HISTORIC AND DESIGN REVIEW COMMISSION

HDRC CASE NO: 2017-460
ADDRESS: 1110 BURNET ST
LEGAL DESCRIPTION: NCB 1665 BLK 1 LOT 12
ZONING: R-6, H
CITY COUNCIL DIST.: 2
DISTRICT: Dignowity Hill Historic District
APPLICANT: Felix Ziga/Ziga Architecture Studio
OWNER: Poma Properties, LLC
TYPE OF WORK: Rehabilitation; Rear Addition; Driveway; Rear Yard Fence
REQUEST:

HISTORIC REHABILITATION &
ADDITION
1110 BURNET ST.
SAN ANTONIO, TX 78202
POMA PROPERTIES, LLC

2 PROPOSED SITE PLAN

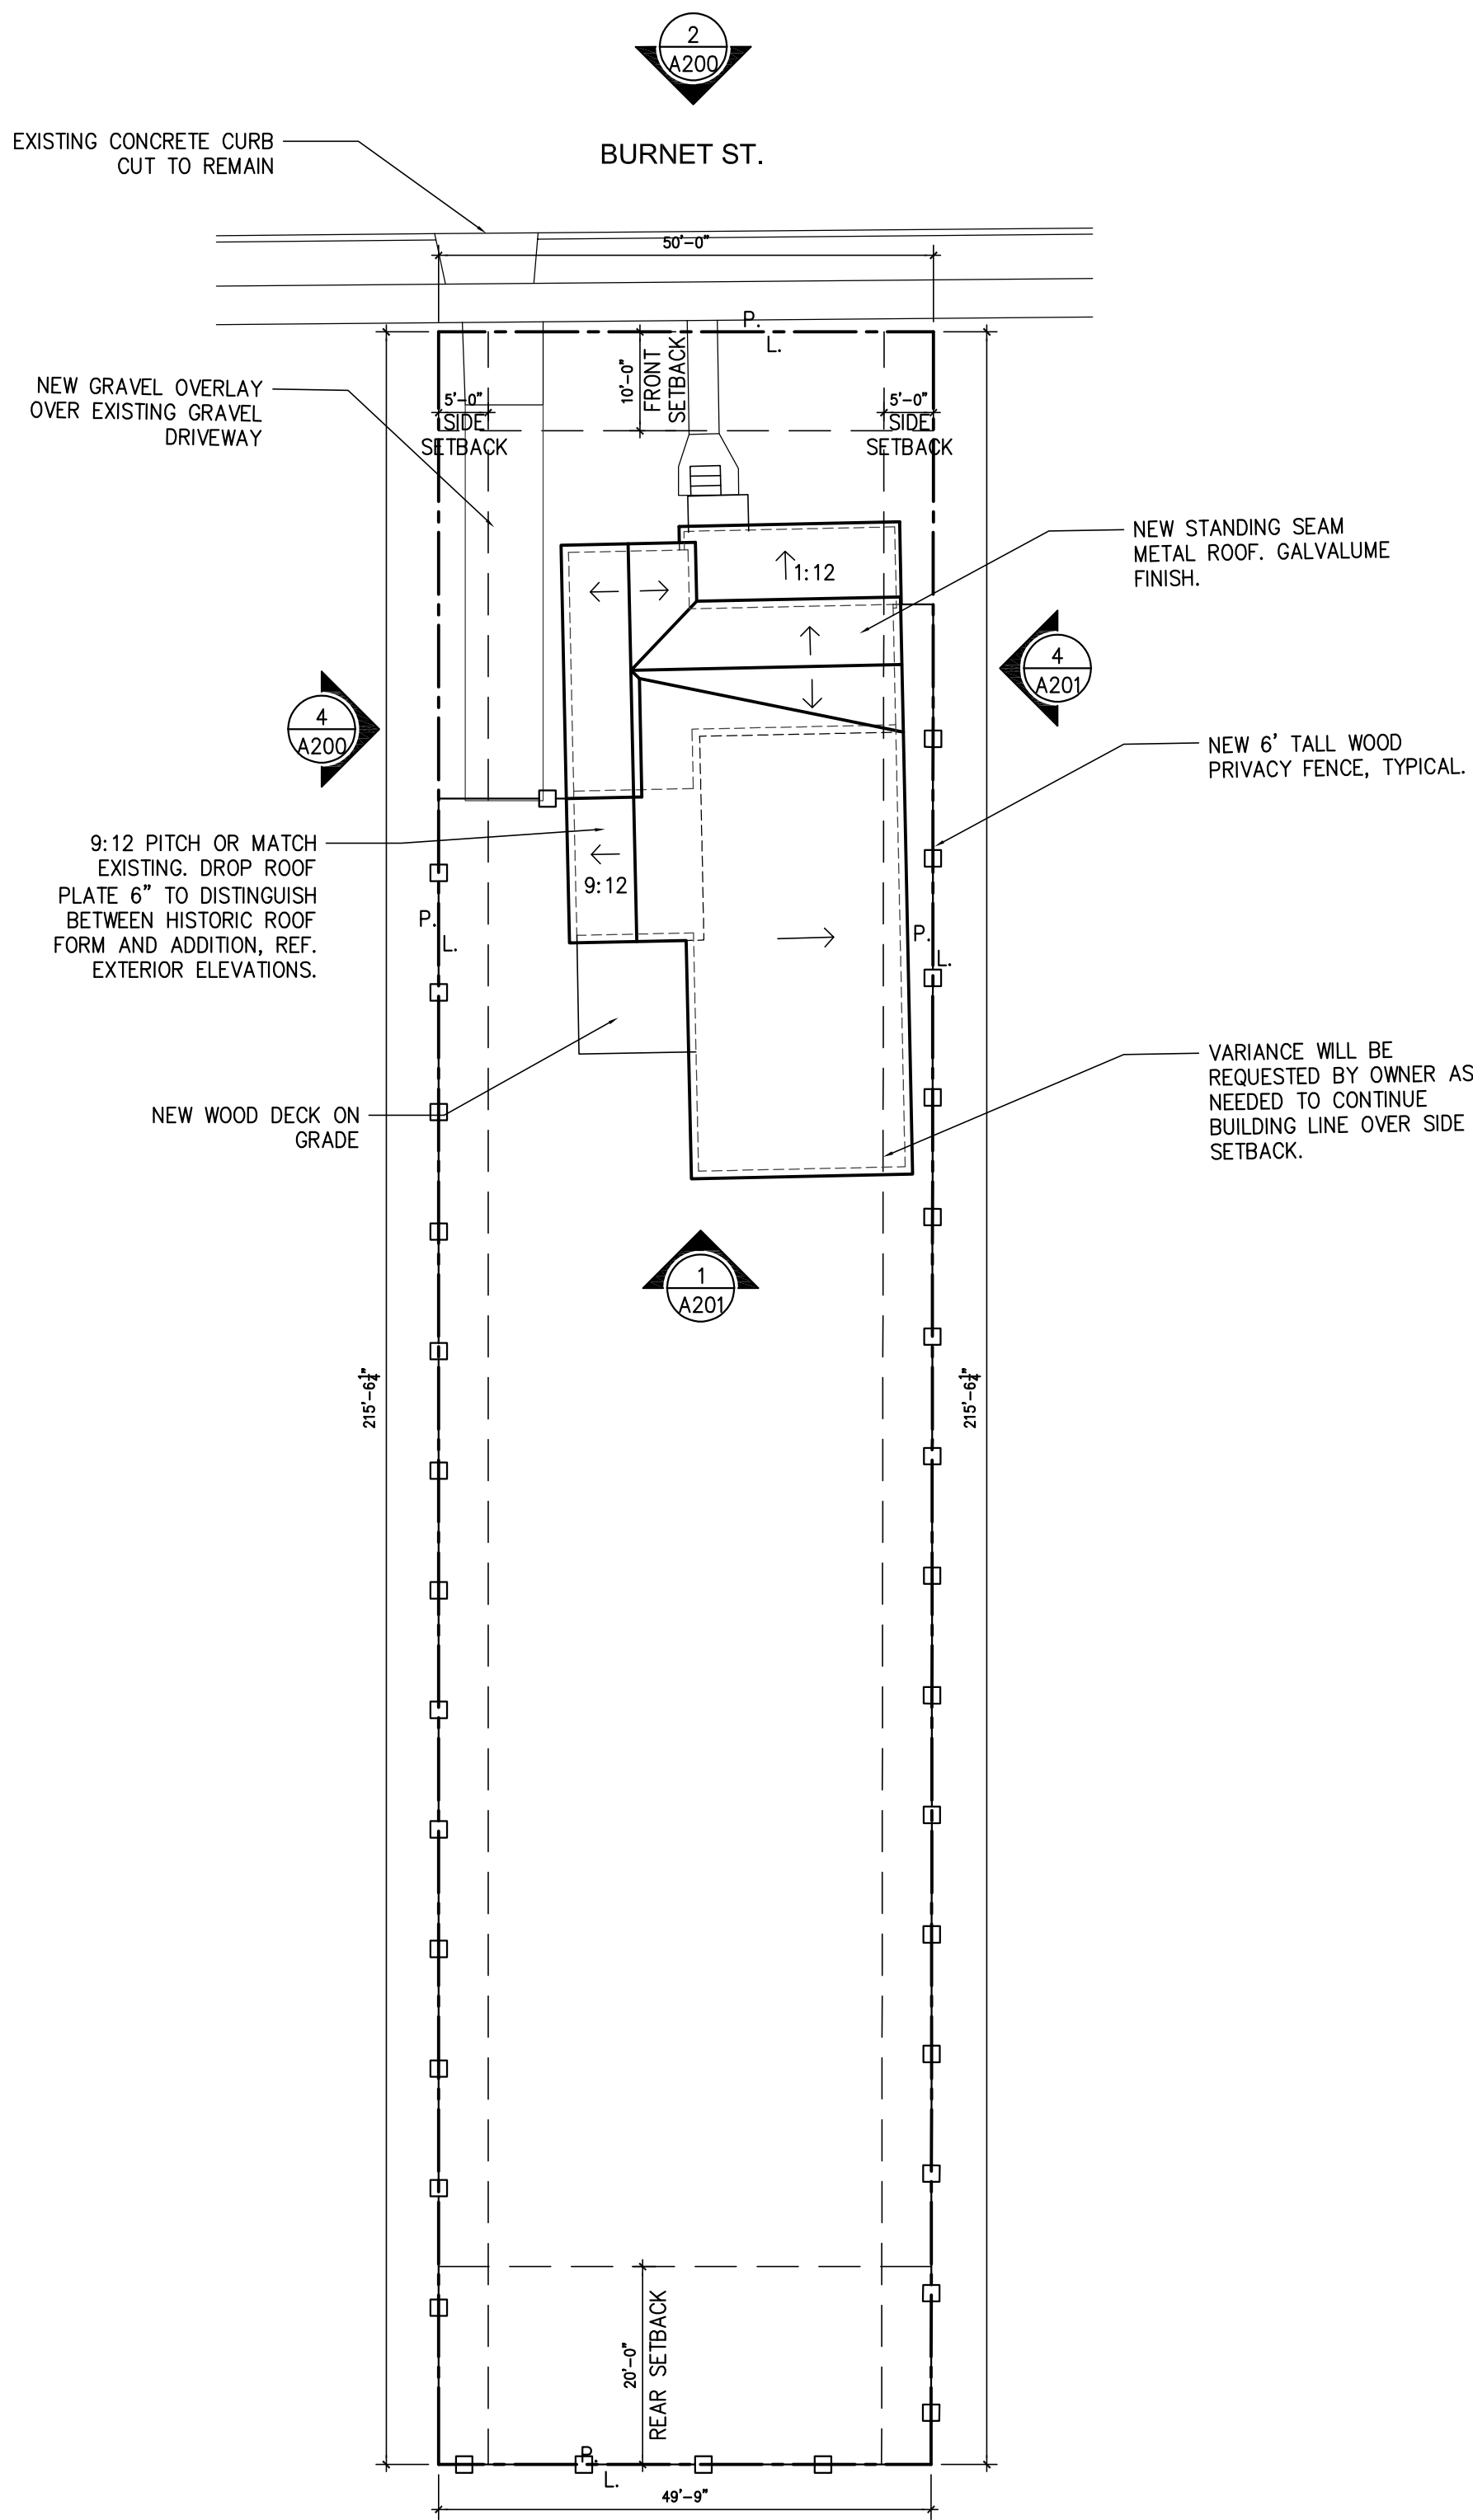
- i. FENCING – The property currently features a chain link fence. The applicant has proposed to remove this fence and install a wood picket fence to feature six (6) feet in height. The applicant has proposed for the fence to extend to the front wall plane of the historic structure on the east façade. Staff finds that the proposed privacy fence should feature a setback from the front wall plane.

- j. DRIVEWAY MODIFICATIONS – The driveway is currently a concrete ribbon strip that is deteriorated. The applicant has proposed to overlay gravel over the existing ribbon strip driveway. Staff finds that the applicant should adhere to the Guidelines for Site Elements and repair the existing, ribbon strip profile.

- i. That the proposed privacy fence feature a setback from the front wall plane on the east façade as noted in finding i.

Staff does not recommend approval of item #6, the overlaying of gravel over the existing ribbon strip driveway. Staff recommends the applicant repair the existing, concrete ribbon strip driveway.

2 PROPOSED FLOOR PLAN
SCALE: 1/4"=1'-0"

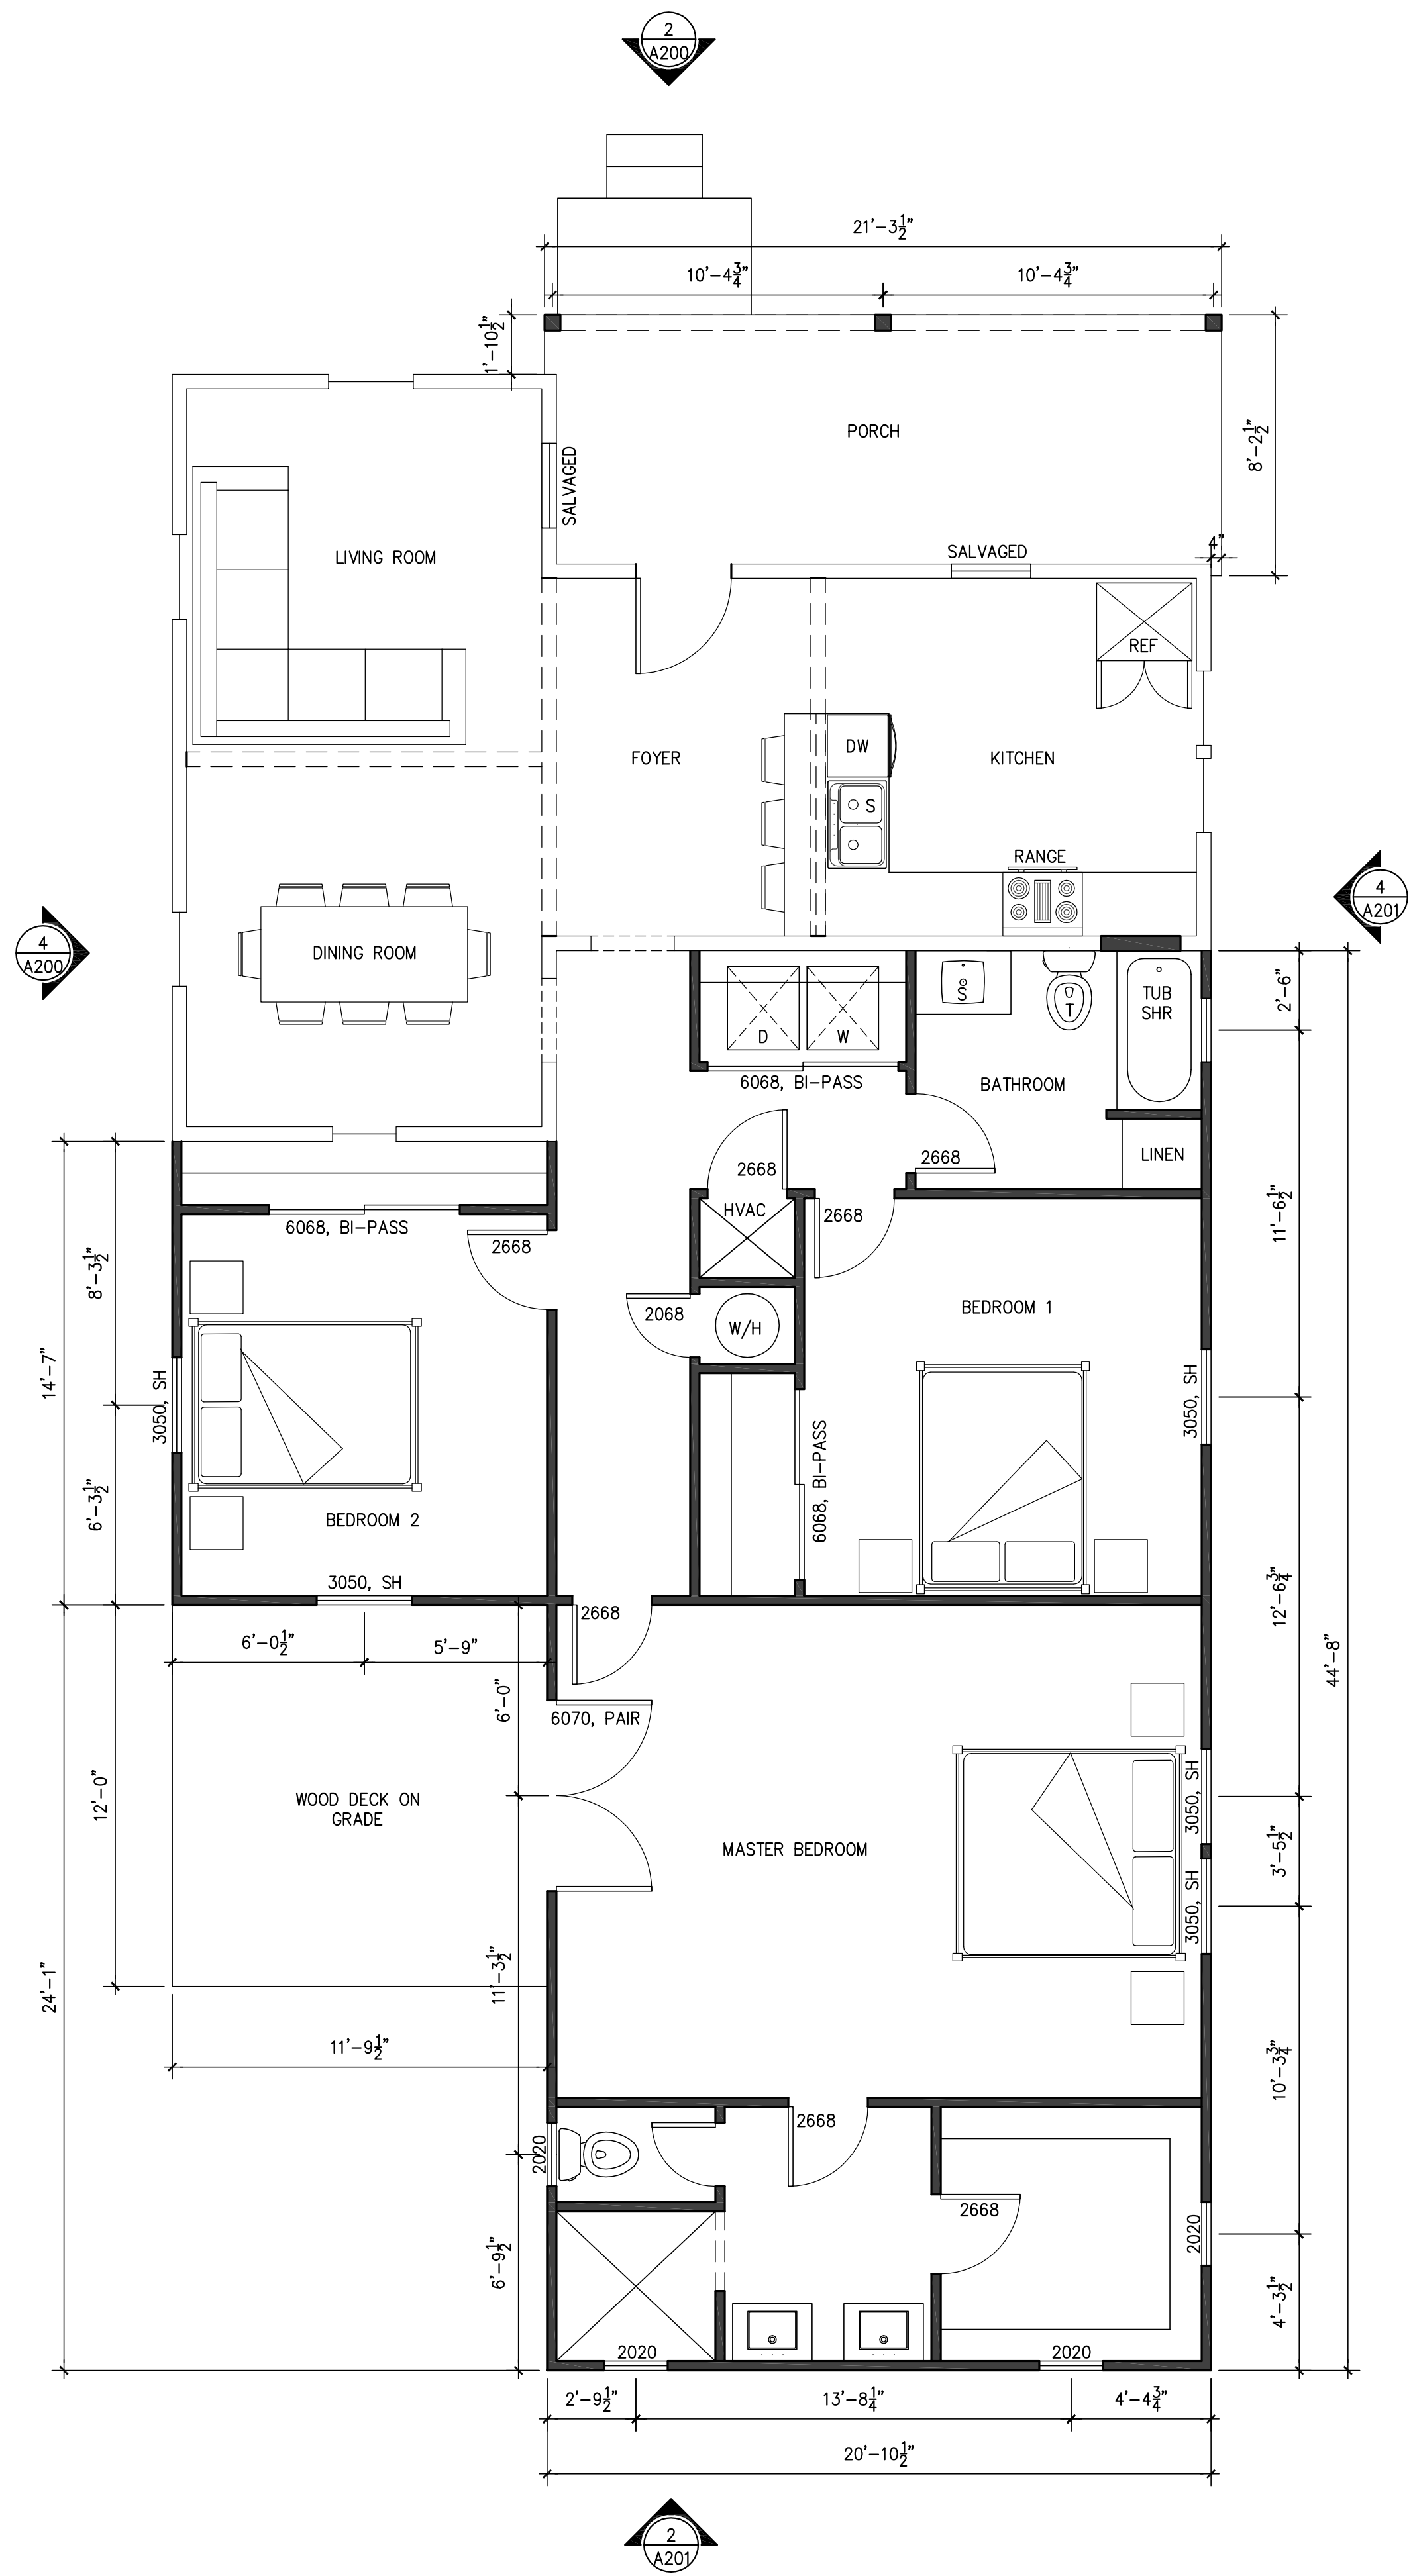
- e. **REAR ADDITION** – At the rear of the primary historic structure, the applicant has proposed to construct a rear addition to feature one story and approximately 1,100 square feet. The Guidelines for Additions 1.A. states that additions should be sited to minimize visual impact from the public right of way, should be designed to be in keeping with the historic context of the block, should utilize a similar roof form and should feature a transition between the old and the new. The applicant has proposed for the addition to include both a rear facing gabled roof and a shed roof. While the gabled roof is appropriate for the architecture of the historic structure, staff finds the large shed roof to be inappropriate. Staff recommends the applicant replace the proposed shed roof with a gabled roof or a roof form that is complementary of the architecture of the historic structure.

- g. **SCALE, MASS AND FORM** – Regarding footprint, the applicant has proposed for the addition to share a wall plane on the east façade that is the same as that of the historic structure. This addition would not comply with the side yard setback. Staff finds that an inset should be included to not only satisfy the Guidelines regarding a setback in wall planes, but also to comply with side yard setback regulations.

- i. That the applicant replace the proposed shed roof with a gabled roof or a roof form that is complementary of the architecture of the historic structure as noted in finding e.

- ii. That an inset should be included to not only satisfy the Guidelines regarding a setback in wall planes, but also to comply with side yard setback regulations as noted in finding g.
